Application No.: 10/808,646

REMARKS

Annotated Sheet Showing Changes
Application Serial No. 10/808,646
Response to Official Action Dated May 26, 2005
Attorney Docket No. 81094716

Fig. 5 norwarbened FIG. 5 norwarbened FIG. 5 norwarbened

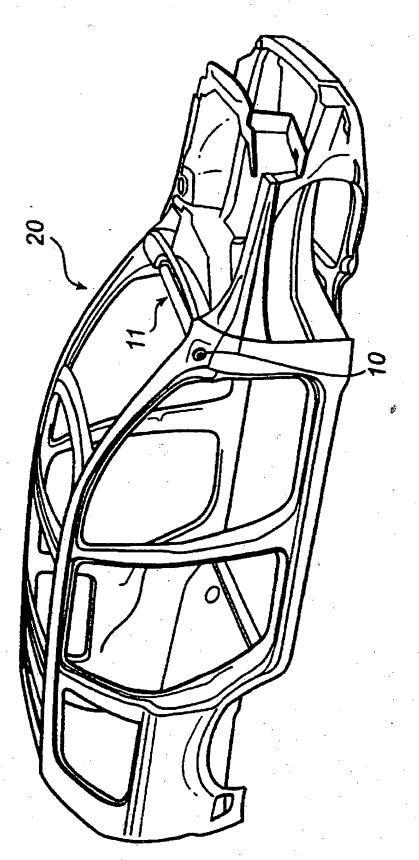
The attached drawing sheets include changes to Fig. 5, where Fig. 5 has been renumbered as Fig. 3.

In the Office Action, the drawings stand objected to for failing to disclose the hard stop recited in claim 8, and the instrument panel recited in claim 9.

With regard to dependent claim 9, Applicant respectfully directs the Examiner's attention to original Fig. 5 (now Fig. 3) of the original drawings, which shows an instrument panel at element 11, (see also page 9, lines 3-7).
